**Second Interim Collection  
of the  
National Electrical Safety Code  
Interpretations  
1991-1993 inclusive**

**Abstract:** This edition includes official interpretations of the National Electrical Safety Code as made by the Interpretations Subcommittee of the National Electrical Safety Code Committee, ANSI C2.

**Fig IR 448-1**

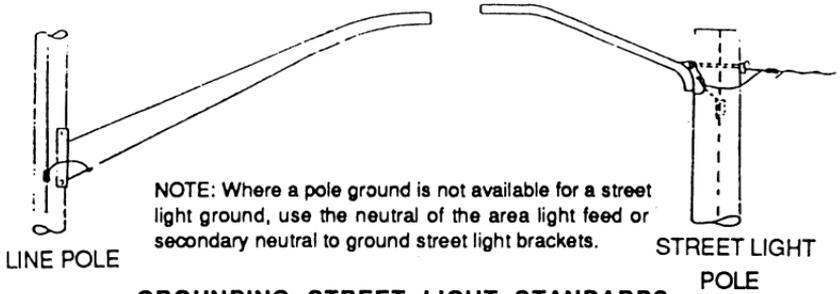
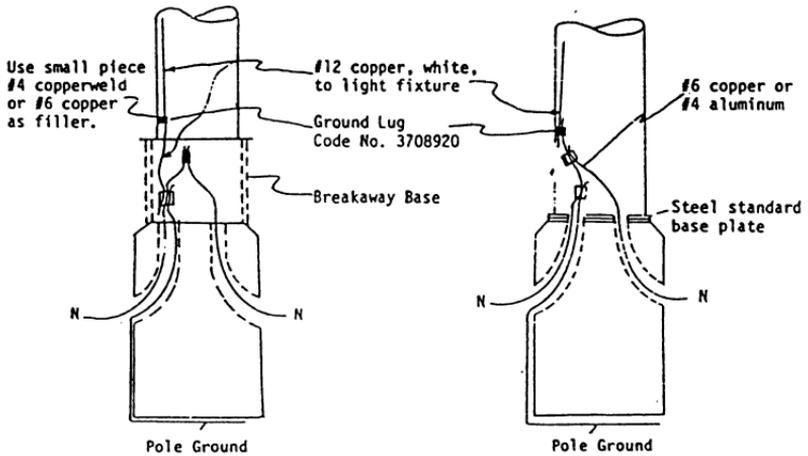
This company's specifications require using the grounded (neutral) conductor not only as the multiwire branch circuit conductor, but also as the equipment grounding conductor for bonding the noncurrent-carrying metal parts. Their standards experts quoted NESC Section 9 (92B1) as the source for requiring the use of the grounded conductor as a grounding conductor. I am enclosing a drawing of the company's requirements.

Section 410-15 (b) of the NEC requires the metal poles be bonded with a grounding conductor recognized by Section 250-91 (b). Section 250-61 (b) is very specific in not allowing the use of the grounded conductor for grounding the noncurrent-carrying metal parts of equipment on the load side of the service disconnecting means.

I feel that Section 92B1 of the NESC agrees with the NEC by stating, "The grounding connections shall be made at the source, and at the line side of all service equipment." I would appreciate an interpretation of Section 9 of the NESC on using the grounded conductor as a grounding conductor for bonding the noncurrent-carrying metal parts in a situation similar to the one described.

To ensure that the breakaway base functions in the proper manner, the #12 ground conductor shall run through the grounding lug and connect to the neutral conductor. The grounding lug is too large for the #12 conductor and a small piece of #4 copperweld or #6 copper shall be used to fill the lug. See Street Light Chapter for complete wiring installation detail.

The fundamental question to be answered is whether the NEC or the NESC should be applied. The NESC applies if the facility is operated and maintained by a utility, as covered by Rule 011. Under these conditions, the grounding system described in the request for interpretation meets NESC requirements. Specifically, the NESC does not require a separate grounding conductor, in parallel with an effectively grounded neutral, for grounding of metal poles.

However, the requestor states: "The project consists of service equipment feeding 120 V fixtures...on metal poles...fed with underground branch circuits." If this project consists of a low-voltage distribution system operated and maintained by a nonutility entity, the NEC applies. The NESC Interpretations Subcommittee is not empowered to interpret NEC requirements.

**Fig IR 454-2**  
**Side View**

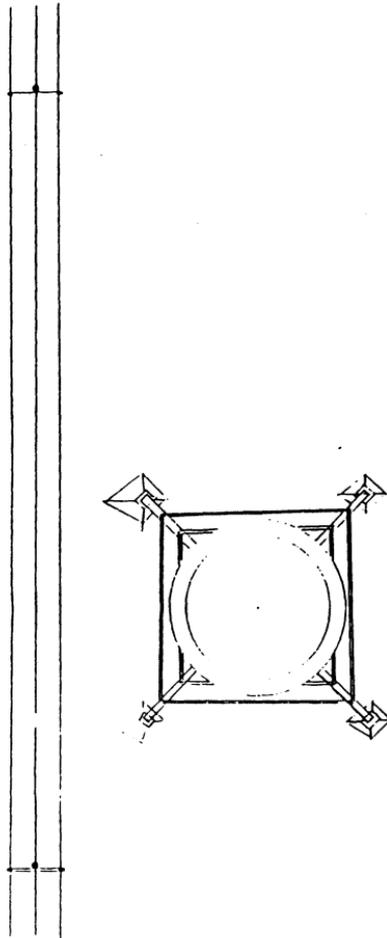
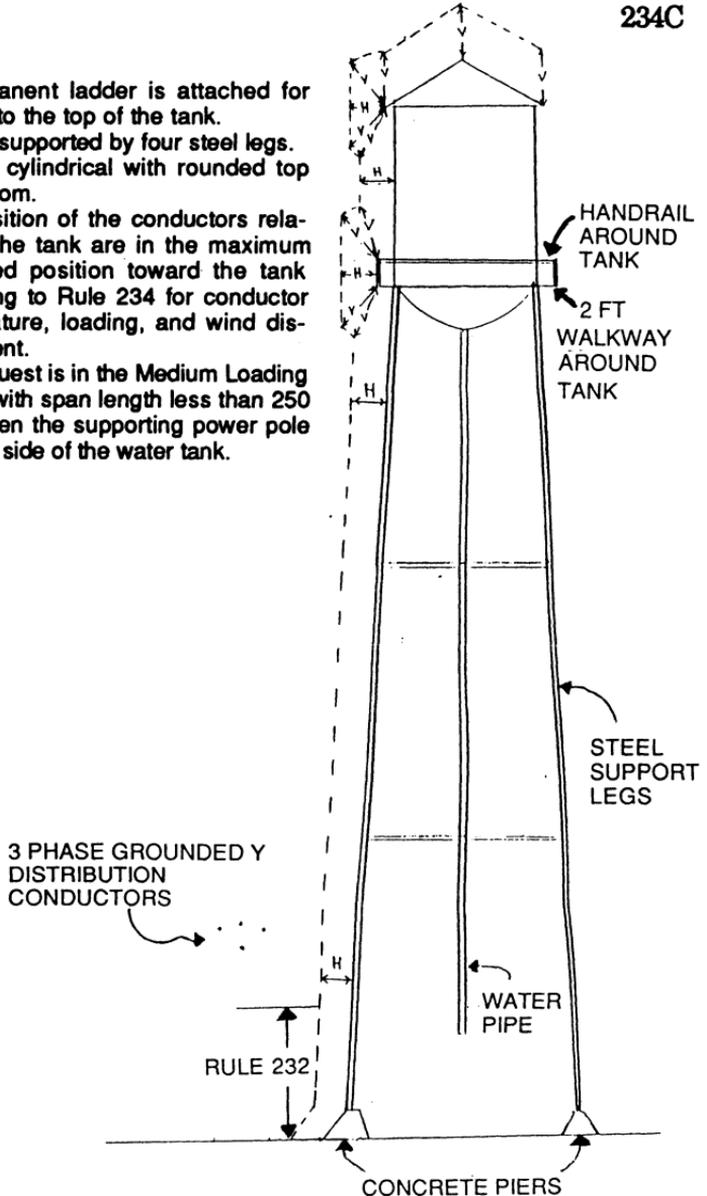
The tanks are constructed similar to the attached drawing with four metal legs supporting the tanks. The horizontal distance between legs is greater at the ground than at the tank. In any of our tank locations (as represented on the attached drawing) the horizontal distance clearance requirement and the diagonal distance from the conductor to the nearest point on the structure 15 greater than the vertical clearance requirement of Table 234-1. Also, the conductors are higher above ground than the code requirement by Table 232-1.

Our understanding of the clearance envelope is indicated on the attached drawing; however, the code is not clear in Section 234C as to how the horizontal requirement should be applied to a side of the water tank support leg that has a slight lean such as is the case on our attached drawing. Also, the Clearance Diagrams for Building and Other Structures in Figure 234-1 do not address our specific concern. In each of these clearance diagrams the horizontal measurement is from a vertical surface. Should the horizontal measurement be made horizontally from the conductor to the leaning support leg or perpendicular to the support leg out to the conductor?

- (1) A permanent ladder is attached for access to the top of the tank.
- (2) Tank is supported by four steel legs.
- (3) Tank is cylindrical with rounded top and bottom.
- (4) The position of the conductors relative to the tank are in the maximum displaced position toward the tank according to Rule 234 for conductor temperature, loading, and wind displacement.
- (5) This request is in the Medium Loading District with span length less than 250 ft between the supporting power pole on each side of the water tank.

(In process)

**Fig IR 453-1**  
**Top View**

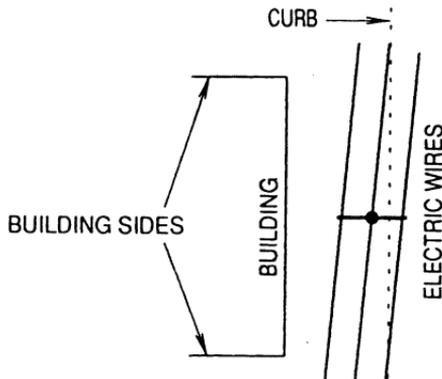
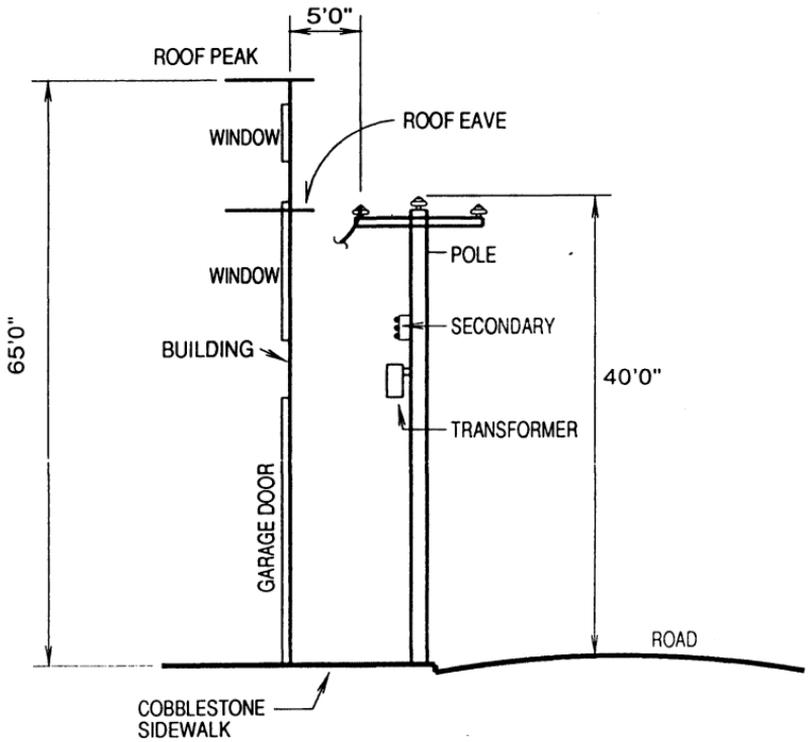
Please explain the meaning of the last five lines of Rule 234C1—the zone as applied under the conditions shown in the enclosed figures.

The description of the clear space or zone in Rule 234C1 is specific; it is a clear space at least 6 ft wide located either:

- (a) adjacent to the building, or
- (b) beginning not over 8 ft from the building

1. It applies where buildings or other installations exceed three stories or 50 ft in height.
2. It is a "should" or advisory rule, to be followed insofar as practical (see Rule 015, 1987 Edition).
3. It does not apply if the Exception to Rule 234C1 governs.
4. See also Rule 234A1, 1987 Edition, for wind displacement requirements.

The Interpretations Subcommittee cannot comment on specific installations such as the graphic included with your request for interpretation, as this would constitute consulting advice.
